**Application by Tritax Symmetry (Hinckley) Limited for an Order Granting Development Consent for the Hinckley National Rail Freight Interchange (HNRFI)**

**Adequacy of Consultation representation**

## **Adequacy of Consultation Representation**

Figure 4.1: Zone of Theoretical Visibility of Proposed Parameters

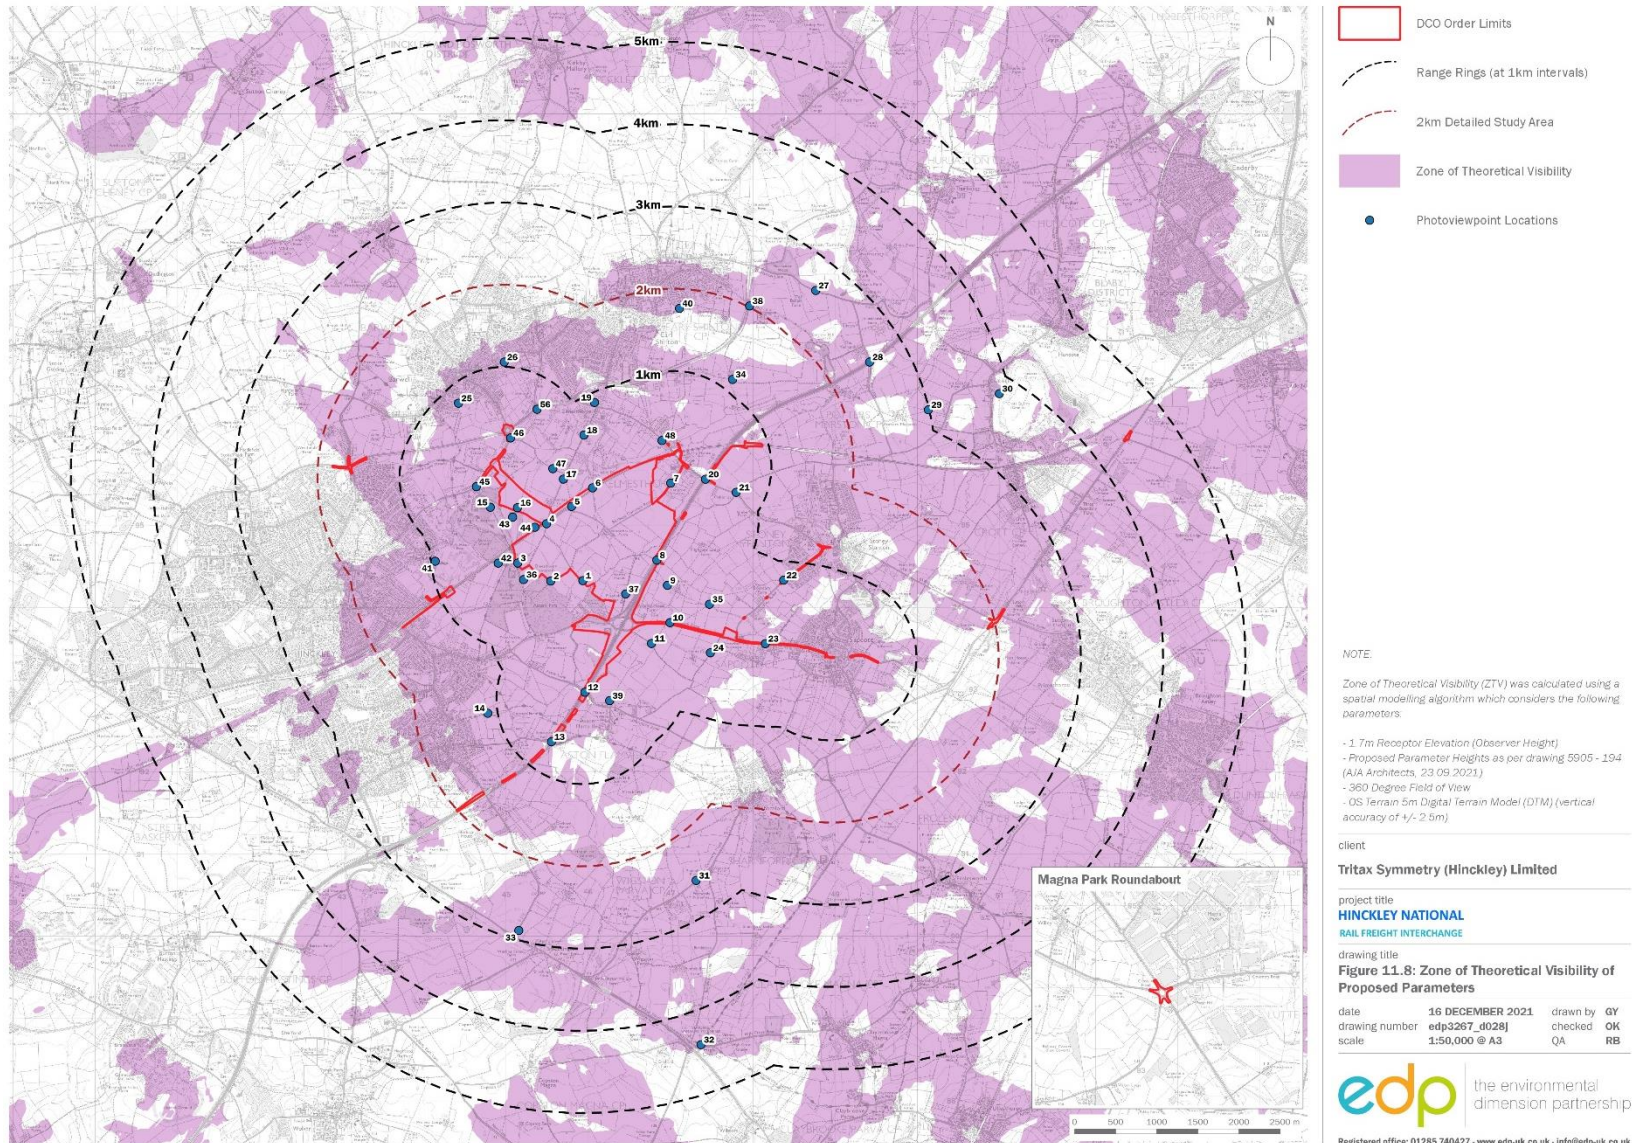
**4.2** The Zone of Theoretical Visibility (ZTV) map indicates theoretical visibility from parts of all of these settlements and surrounding landscapes. The ZTV (Figure 11.8) is reproduced in Figure 4.1. in this report.

Figure 4.2: Significant visual effects at Year 15 of operation

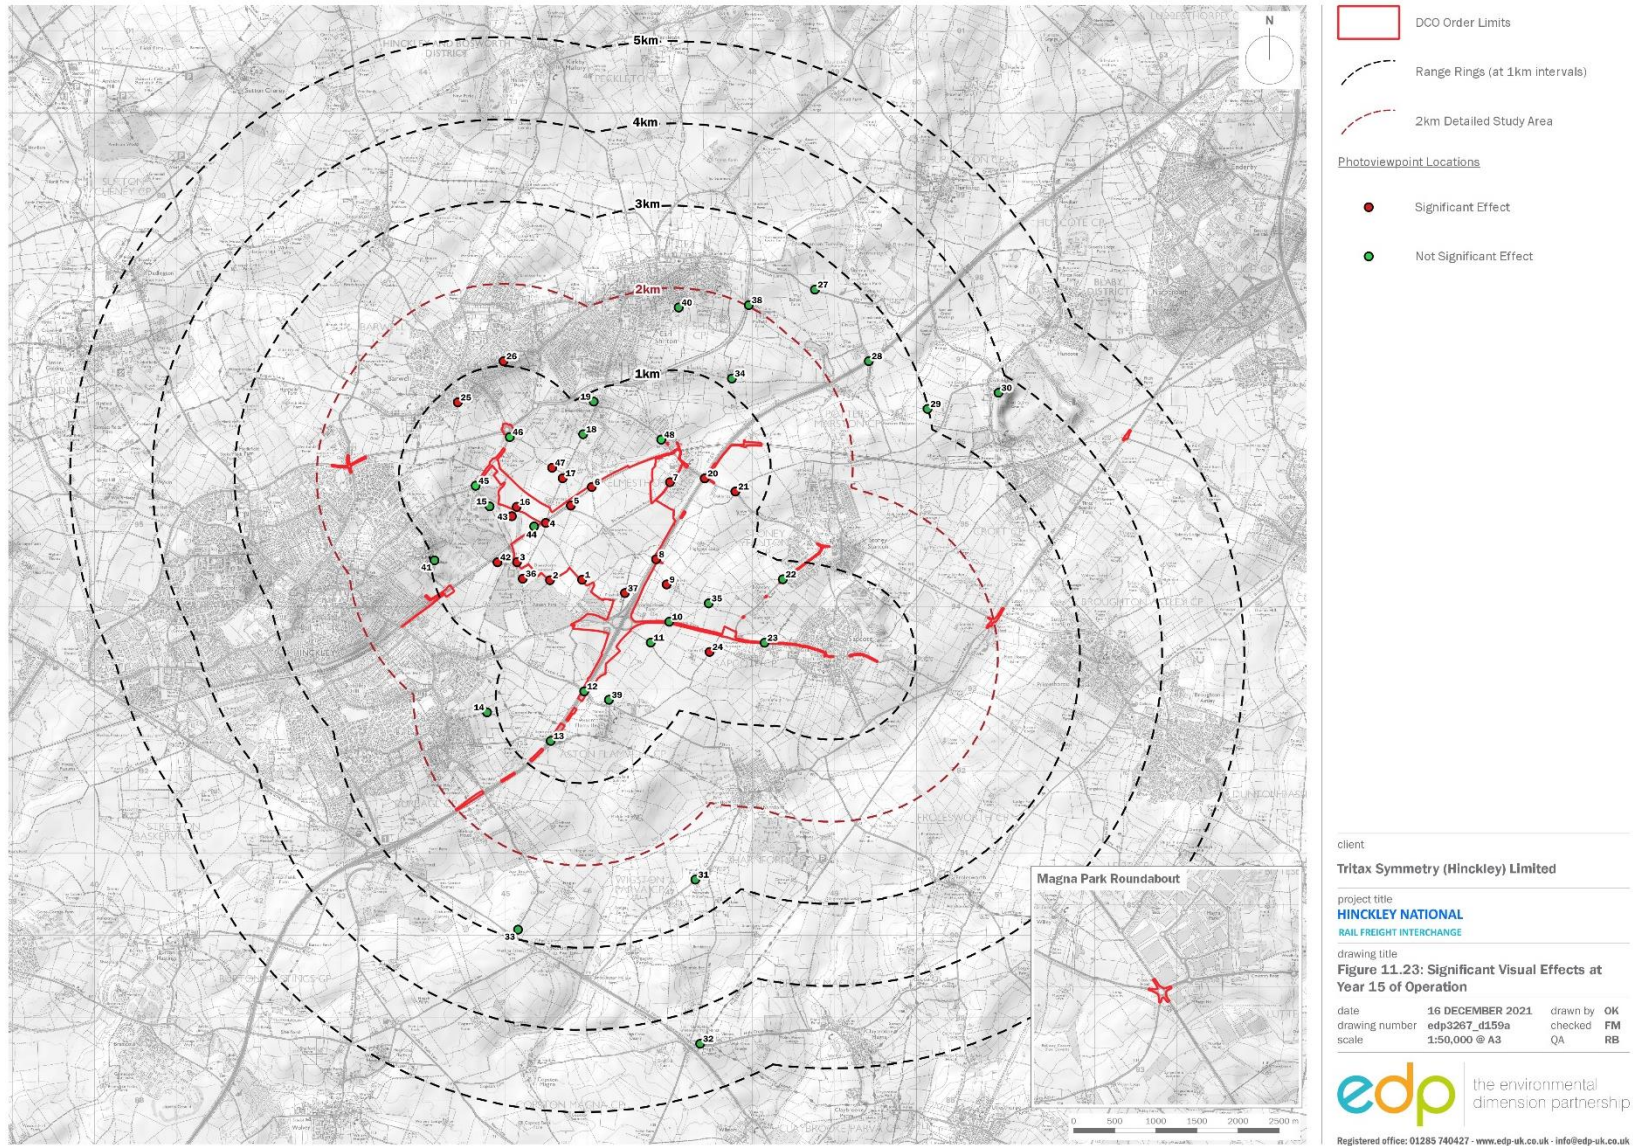
**4.12** The geographic extent of viewpoints with significant effects is shown Figure 4.2 (reproduced Figure 11.23 from the LVIA below).

Figure 15 (page 133) of Leicester and Leicestershire Authorities Report Warehousing and Logistics in Leicester and Leicestershire: Managing Growth and Change

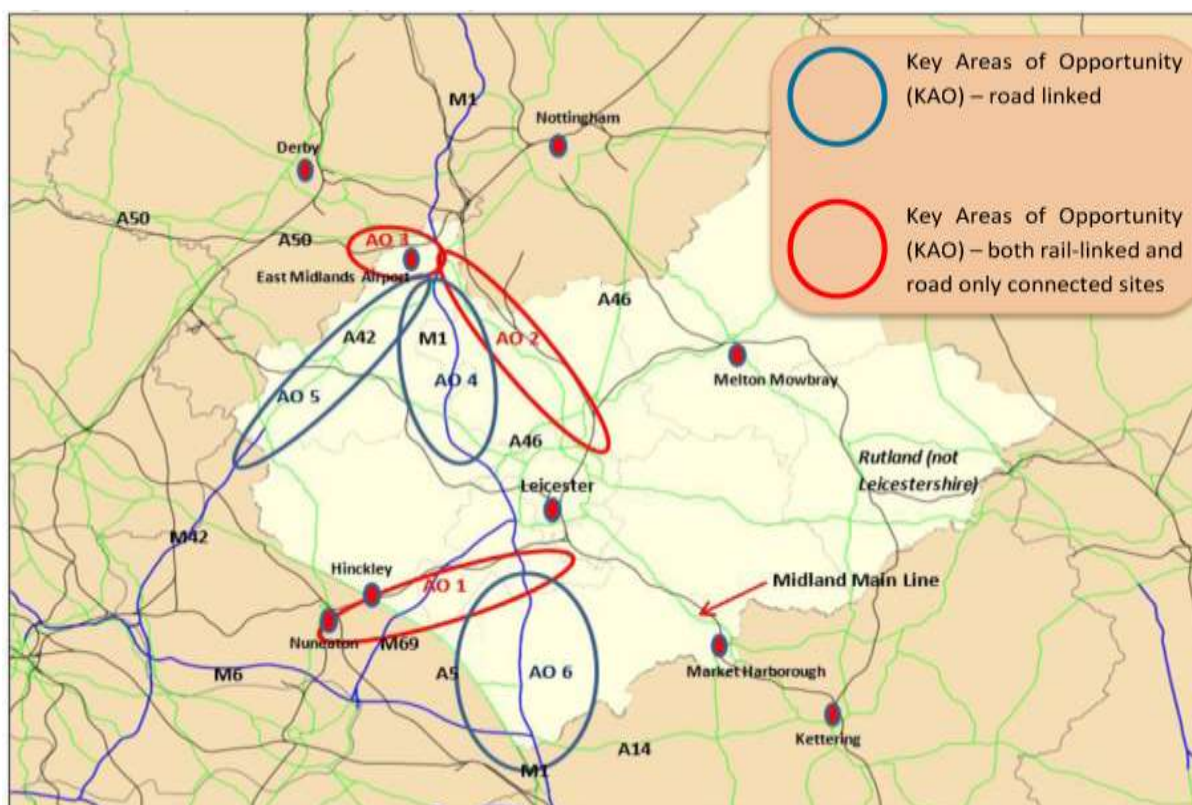
The need for the facility appears to rely upon the Leicester and Leicestershire Authorities Report Warehousing and Logistics in Leicester and Leicestershire: Managing Growth and Change (April 2021). This report identifies three locations for potential rail-linked and road only connected employment sites (Figure 15). This report continues, noting that there is no hierarchy in respect of the various opportunity areas noted, and that these are identified *“in order to maintain and enhance Leicestershire’s competitive position”* in the employment market (paragraph 11.11). The identified need in this specific location is not therefore underpinned by a national requirement for a facility, but merely as a desire of the local authorities to ensure a strong position is maintained for employment distribution sites. It is appreciated that it may align in principle with the national aims, but seemingly with no support for this specific location.

The background policy context/support for this development coming forward raises two immediate questions/short-comings of the evidence base, which are considered in turn below.

The selected site and assessment undertaken has been based upon land within Leicestershire coming forward. Whilst the areas of opportunity as noted on Figure 15 of the Leicester and Leicestershire Authorities Warehousing and Logistics Report states that these areas are only indicative and not precise, it is clearly illustrating within Area A01 the desire to provide employment between Leicester and Hinckley, juxtaposed to the Leicester-Nuneaton trainline. The supporting text of paragraph 11.8 reconfirms the visualisation of Figure 15.

Figure 17 (page 43) of PEIR Appendix 8.1 Interim Transport Assessment

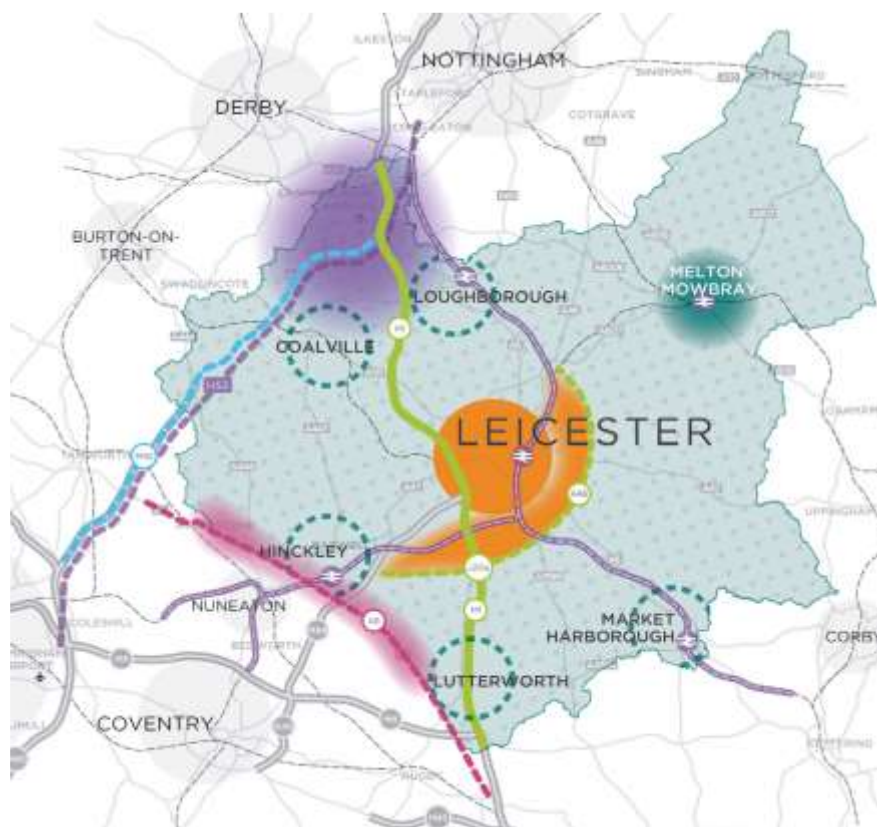
- 3.4 In terms of the highways information that has been presented, from an overview perspective the written Preliminary Environmental Information Report and supporting technical reports present a different position to that stated at the consultation events (presentation information/verbal communication by BWB Highway representatives). Supposedly, all HGV movements from the new development would be directed via the key highway roads (M69 primarily) and not via the secondary roads which run through the surrounding villages. These are highlighted on Figure 17 of the Interim Transport Report as '*HGV desirable routes*' and '*HGV undesirable routes*', with the latter noted to include routes through Stoney Stanton, Sapcote, Barwell, Burbage/Hinckley and Narborough. Ensuring no vehicles come via these routes even with a Travel Plan etc in place is very difficult for Tritax Symmetry to enforce, particularly if container collection is offered, as there is even less ability to control the routes taken by such vehicles. Tritax Symmetry have made reference to the ability to use an Automatic Number Plate Recognition System to control the routes taken, but even this would be difficult to enforce for the HGVs and impossible to control any employee movements, which are likely to be in the thousands every day, given the lack of any public transport or safe ability to travel by non-car borne modes.

- 3.5 Notwithstanding the position presented at the consultation events, it has been indicated within the PEIR Chapter 8: Transport and Traffic section at Table 8.5 (page 8-44) that there would be quite considerable increases in HGVs along many of these roads. This includes in the centre of Sapcote on the B4669 Hinckley Road between Stanton Lane and Sharnford Road (+236.4% change), with the expected level of growth with and without development cited. The development, whether bringing this traffic directly or indirectly is therefore having a very significant impact upon the surrounding highways and settlements, regardless of the intentions of the proposals. This then leads to a second very important question on whether a new bypass should be provided around Sapcote, to mitigate against this severe increase in HGV traffic, as well as increased traffic levels as a whole.
